**SIL Package
10-Pin MicroSiP
Top View**

Schematic/PCB Layout Review:

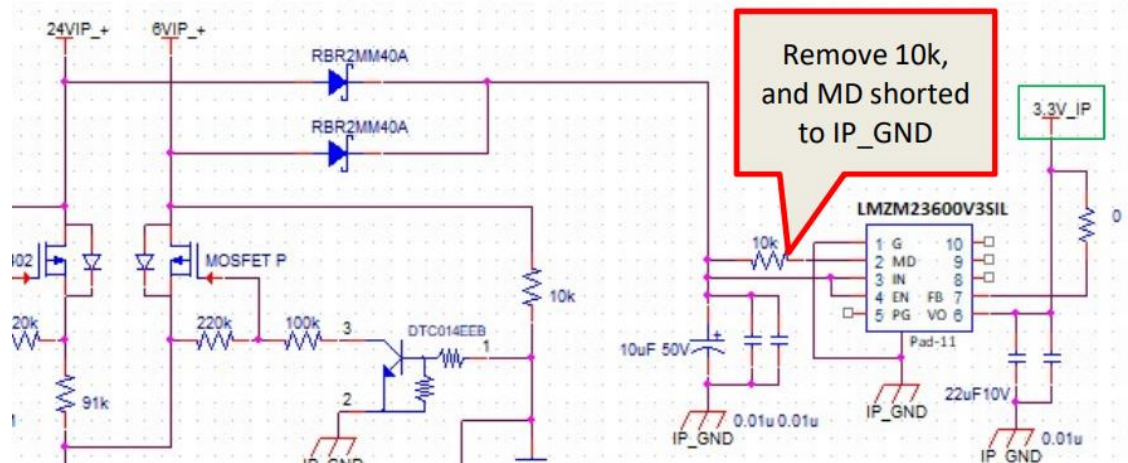
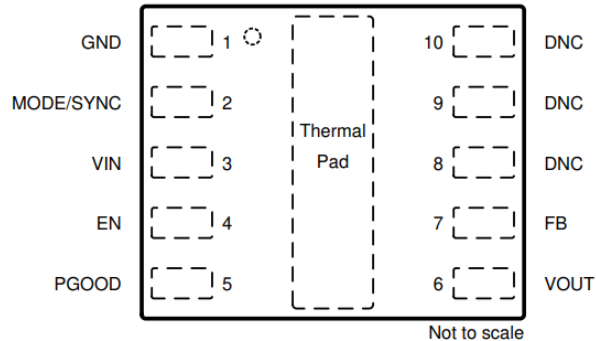
1. Input capacitor placed close to VIN pin (v)
2. Output capacitor is in the minimum output capacitance 22uF, recommend increasing to recommended output capacitance 33uF
3. 10uF electrolytic bulk cap should help suppress over/undershoot of input voltage rail from 24VIP | 6VIP
4. Schematic connection looks correct, I assume the 0 ohm resistor is a placeholder for an injection resistor to measure frequency response?
5. Highlighted resistor in yellow shows the feedback pin getting pulled to GND. What is the purpose of this resistor?
